From: [Peterson, Dana M.](#)
To: "Michael Balaskovits"; [Biazar, Shahab](#)
Cc: [Adeeb, Muhanned W](#); [Kevin Murtagh](#); [Kelly Klein](#); [Olin Brown](#)
Subject: RE: Montage Unit 3B Public Work Order field change. (PWO #775782)
Date: Wednesday, September 18, 2019 12:23:43 PM

From: Michael Balaskovits
Sent: Friday, September 13, 2019 9:37 AM
To: 'Peterson, Dana M.' <dpeterson@cabq.gov>; Biazar, Shahab <sbiazar@cabq.gov>
Cc: Muhanned Adeeb (madeeb@cabq.gov) <madeeb@cabq.gov>; Kevin Murtagh <kmurtagh@bhinc.com>; Kelly Klein <kklein@bhinc.com>; Olin Brown <obrown@bhinc.com>
Subject: Montage Unit 3B Public Work Order field change. (PWO #775782)

De Kooning Avenue
STORM DRAIN SUMP INLETS REVISION
Scale 1"=50'
09-12-2019

MESA DEL SOL MONTAGE UNIT 3B

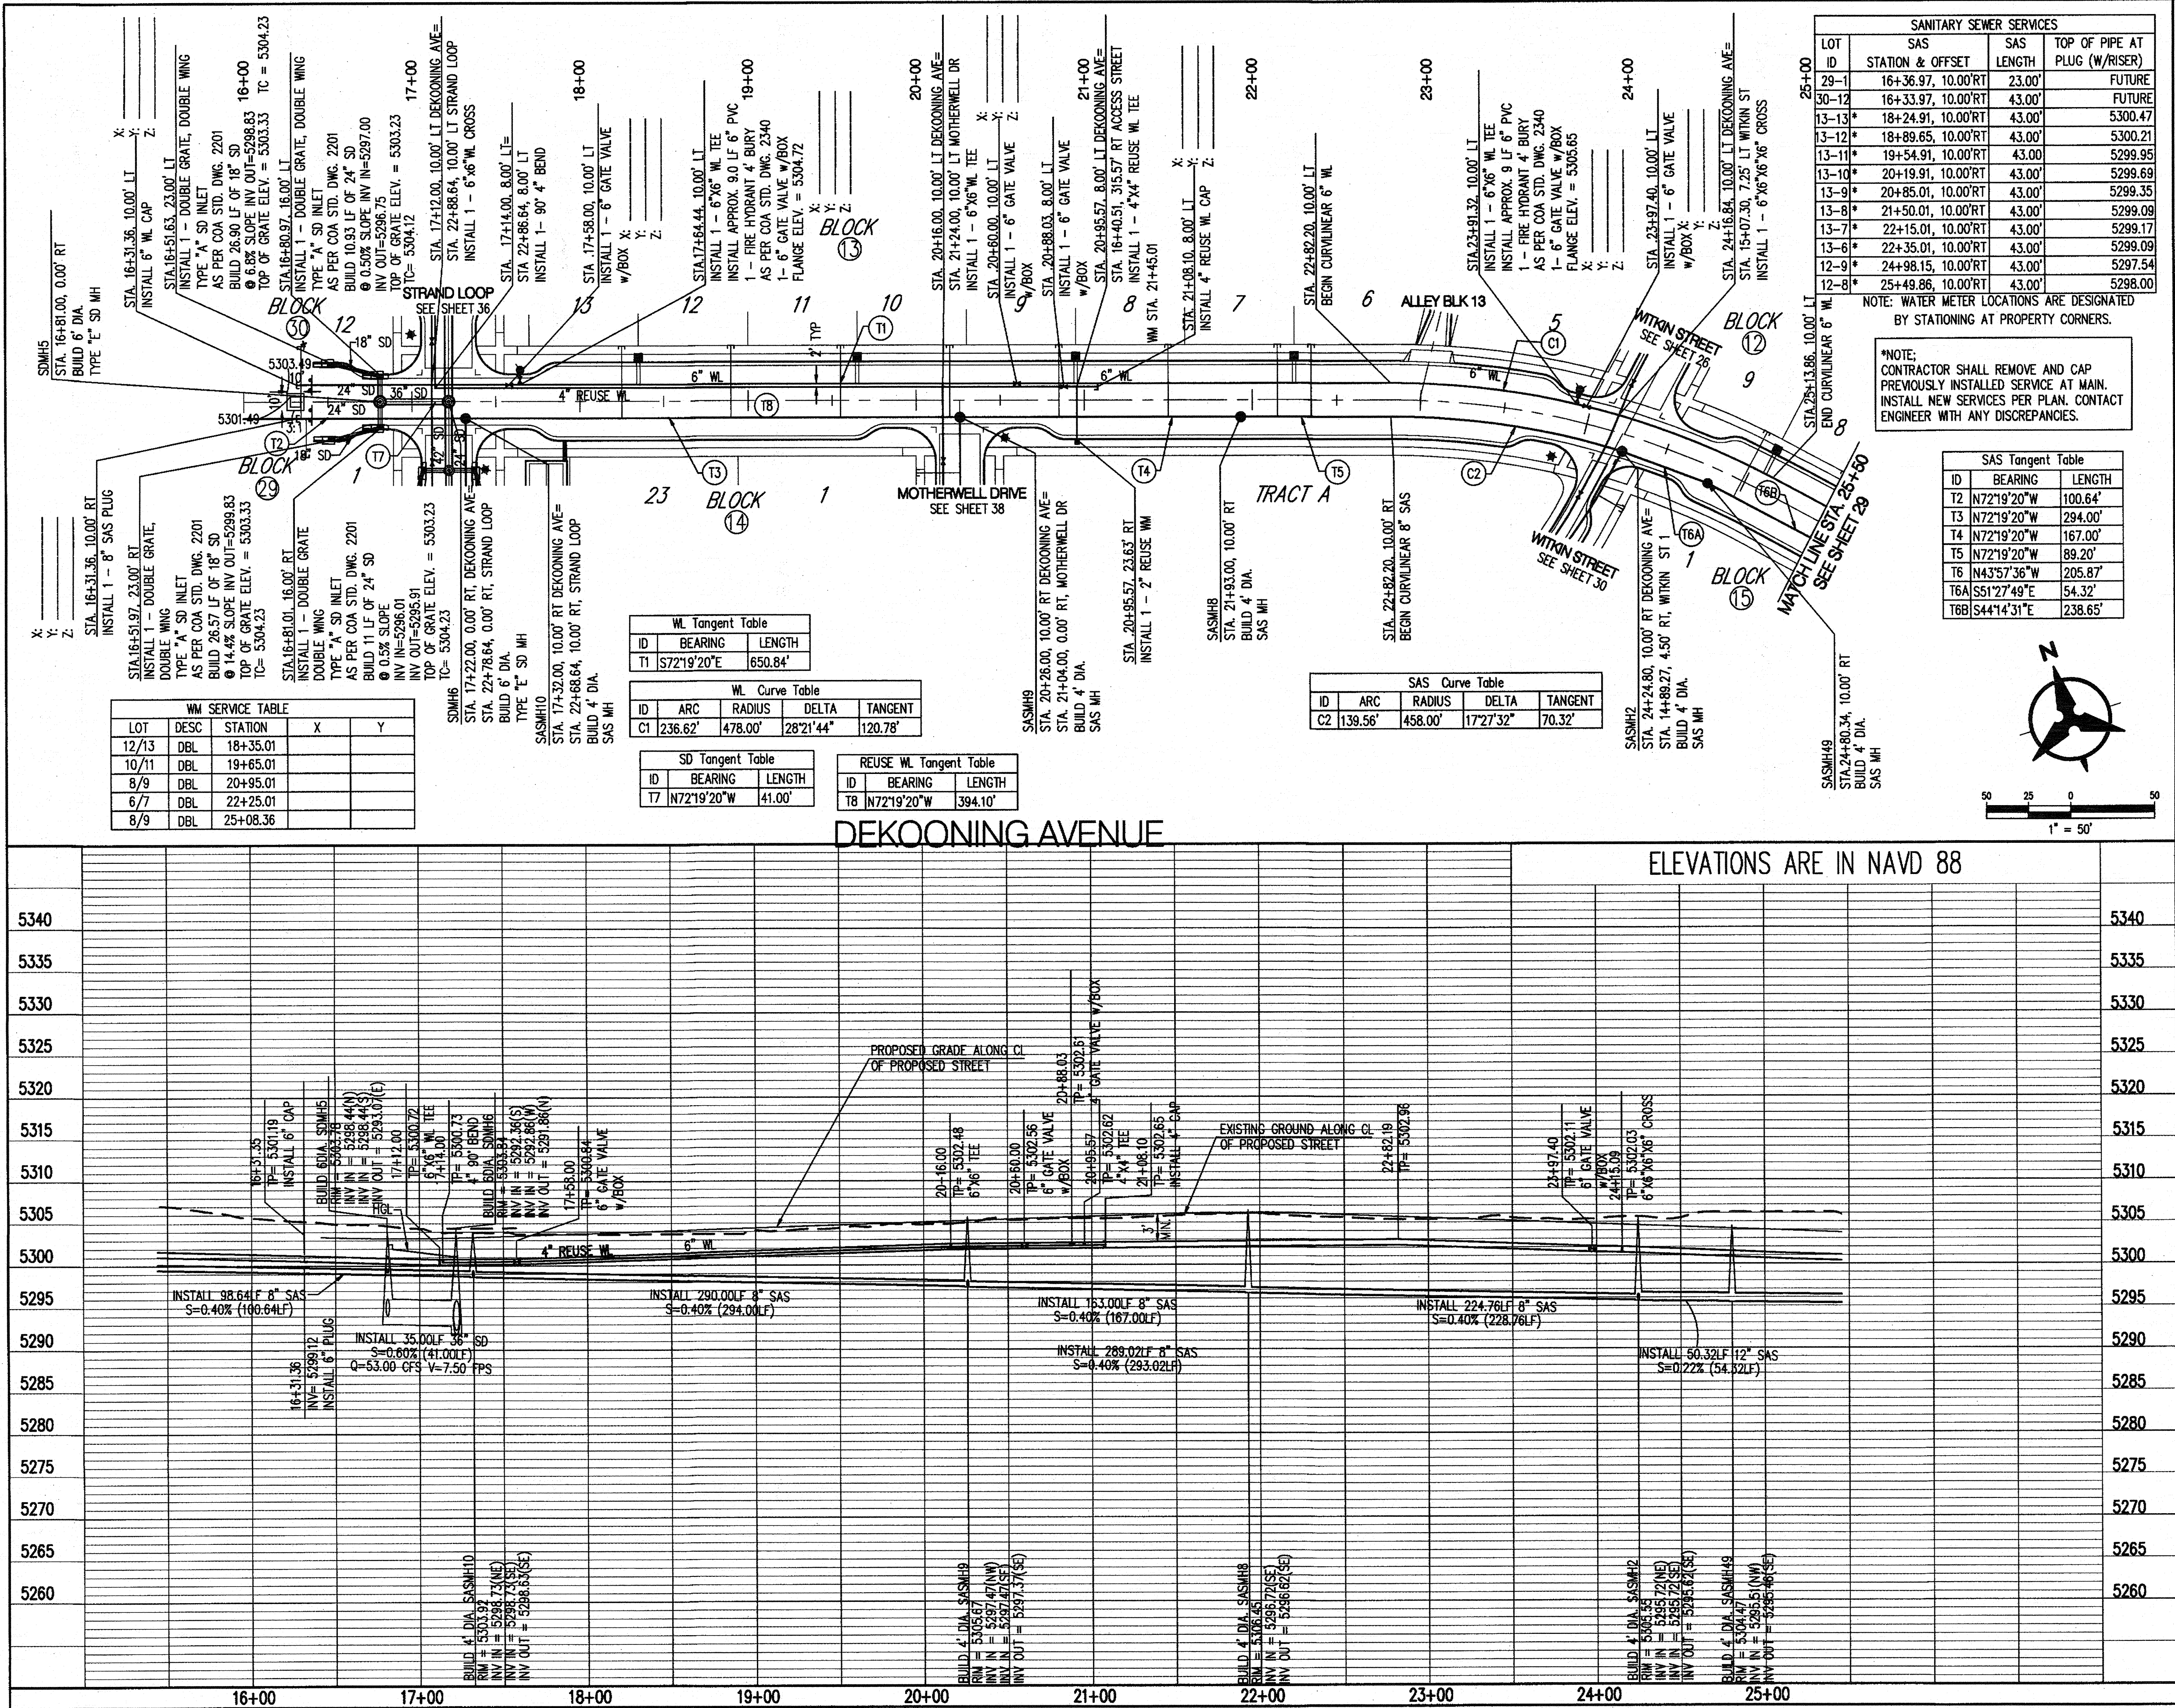
Good morning all it has come to our attention that the double wing, double grate inlet call out at the intersection of de Kooning and Strand Loop (west side of the roadway) will not fit in the tangent provided. (Please refer to sheet 28 and attached for reference). We are proposing changing these inlets to double grate, single wing in order to fit and positioning the wings (or throats) on the upstream end of each inlet. The additional attached information is the revised inlet calculation sheet for the Inlets #5, 6, 11 and 12 that shows the capacity is to the top of the ROW verses the top of curb. This capacity meets the required storm event and overflow necessary for this sump condition. Please review the attached revisions we anticipate issuing to the contractor in the field along with revised inlet calculations. We would ask the contractor to solidify these changes with asbuilt information on the original approved plans. Please let us know if this is acceptable? Thank you.

STA. 16+51.97, 23.00' RT
INSTALL 1 - DOUBLE GRATE,
DOUBLE WING SINGLE WING
TYPE "A" SD INLET
AS PER COA STD. DWG. 2201
BUILD 26.57 LF OF 18" SD
@ 14.4% SLOPE INV OUT=5299.83
TOP OF GRATE ELEV. = 5303.33
TC= 5304.23 5303.10 5303.21

STA. 16+81.01, 16.00' RT
INSTALL 1 - DOUBLE GRATE
DOUBLE WING SINGLE WING
TYPE "A" SD INLET
AS PER COA STD. DWG. 2201
BUILD 11 LF OF 24" SD
@ 0.5% SLOPE
INV IN=5296.01
INV OUT=5295.91
TOP OF GRATE ELEV. = 5303.23
TC= 5304.23 5303.91

STA. 16+51.63, 23.00' LT
INSTALL 1 - DOUBLE GRATE, DOUBLE WING
TYPE "A" SD INLET
AS PER COA STD. DWG. 2201
BUILD 26.90 LF OF 18" SD
@ 6.8% SLOPE INV OUT=5298.83
TOP OF GRATE ELEV. = 5303.33
TC = 5304.23
TOP OF GRATE ELEV. = 5303.21 TC = 5304.10

STA. 16+80.97, 16.00' LT
INSTALL 1 - DOUBLE GRATE, DOUBLE WING
TYPE "A" SD INLET
AS PER COA STD. DWG. 2201
BUILD 10.93 LF OF 24" SD
@ 0.50% SLOPE INV IN=5297.00
INV OUT=5296.75
TOP OF GRATE ELEV. = 5303.23
TC= 5304.12 5303.91

Inlets changed to
Double Gate
Single Wing

I've reviewed your attachments and Hydrology has no objection to the proposed change.

By interpolation
@ Q=13.25cfs,
d=0.51' < 8" curb

By interpolation
@ Q=26.5cfs, (2*100yr)
d=0.81' < 0.9' ROW
